**FIRE STATION #3
IFB # 2010-3946-1905**

Addendum 4

6. Drawing M-8, Hot Water System Flow Diagram, Hot Water Control Sequence:

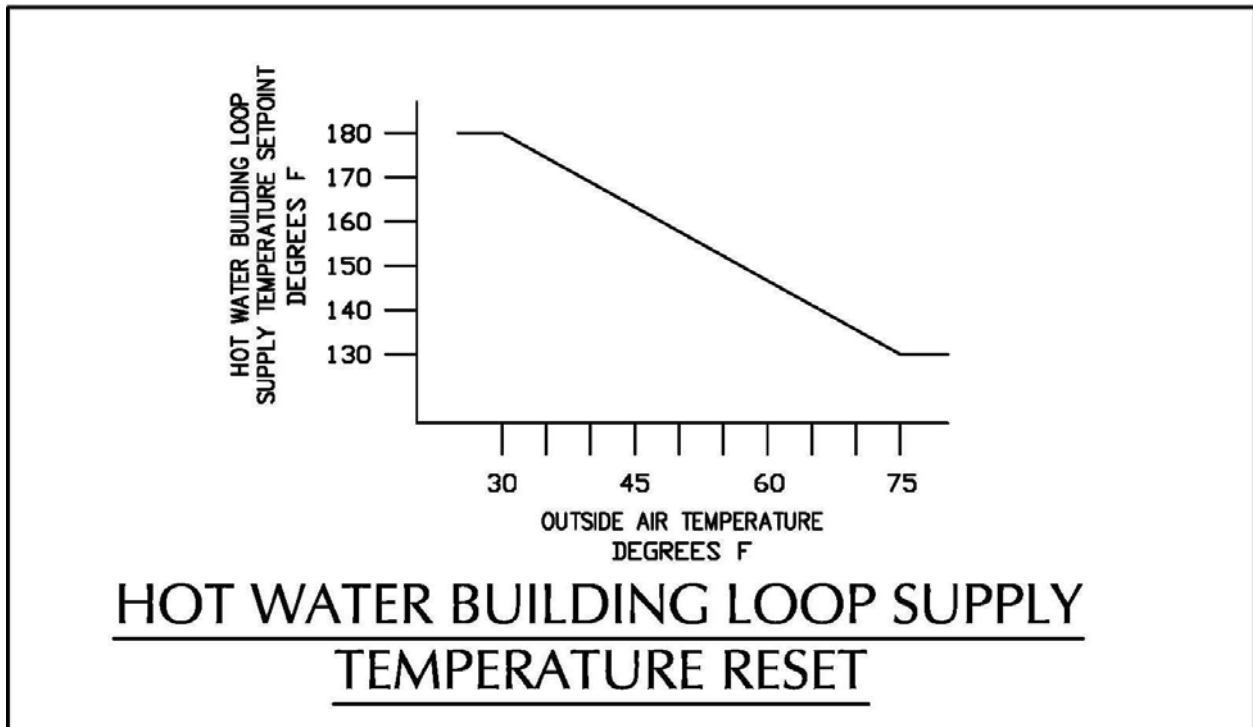
Add the following:

Add the following diagram to drawing M-8:

Add the following diagram to drawing M-8:

“Hot water building loop supply temperature reset:

Reset the hot water building loop supply temperature in straight-line relationship with the outdoor-air temperature for the following conditions:

- a. 180 degrees F hot water building loop supply temperature when outdoor-air temperature is 30 degrees F (adjustable).
- b. 130 degrees F hot water building loop supply temperature when outdoor-air temperature is 75 degrees F (adjustable).

The DDC shall reset the hot water building loop return water temperature setpoint up or down by 1°F increments at 10 minute intervals as required to maintain the building loop supply water temperature at setpoint.”
